## **Statement of Basis**

**Permit to Construct No. P-2011.0113  
Project No. 60891**

**U.S. Department of Energy, Idaho Operations Office (DOE-ID)  
Battelle Energy Alliance, LLC (BEA)  
Idaho National Laboratory (INL)  
Materials and Fuels Complex (MFC)  
Irradiated Materials Characterization Laboratory (IMCL)  
Scoville, Idaho  
Facility ID No. 011-00022**

**FINAL**

Figure 3.1. Location of the IMCL at the MFC.

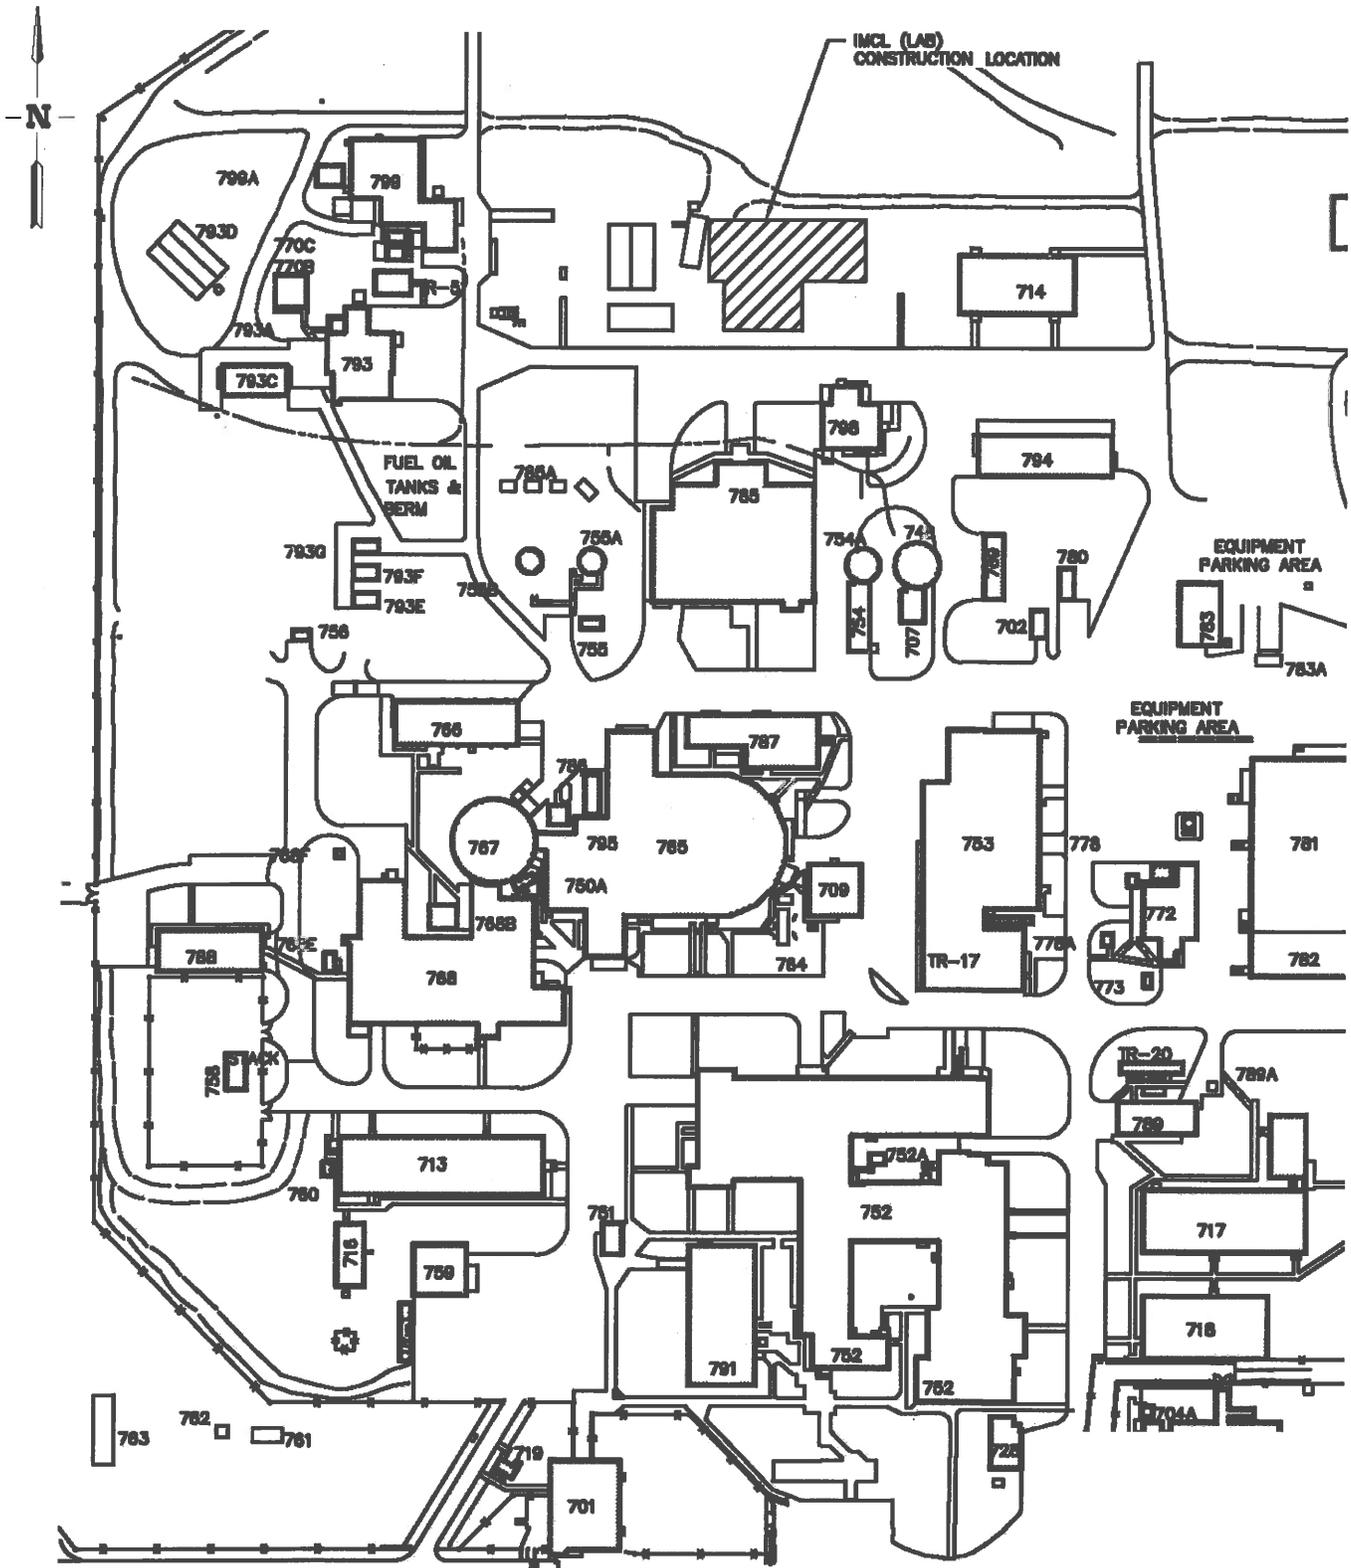
**Comment :** Section 3 of Application- Facility Description- Figures 3.1 and Figure 3.3 at page 5 and 6 are improperly sized and details are unreadable even with magnification. Very few of the internal structures and rooms in the proposed facility are visible to the reader to view. The IDEQ should require a resubmission of schematics and drawings of the proposed facility. The blurred lay-out of the IMCL renders the application incomplete under IDAPA 58.01.01.124.

10. *Section 3 of Application- Facility Description- Figures 3.1 and Figure 3.3 at page 5 and 6 are improperly sized and details are unreadable even with magnification. Very few of the internal structures and rooms in the proposed facility are visible to the reader to view.*

**DEQ Response:** DOE/BEA have provided better figures. Refer to the Permittee's response shown below.

Larger, clearer depictions of Figures 3.1 and 3.3 are provided below.
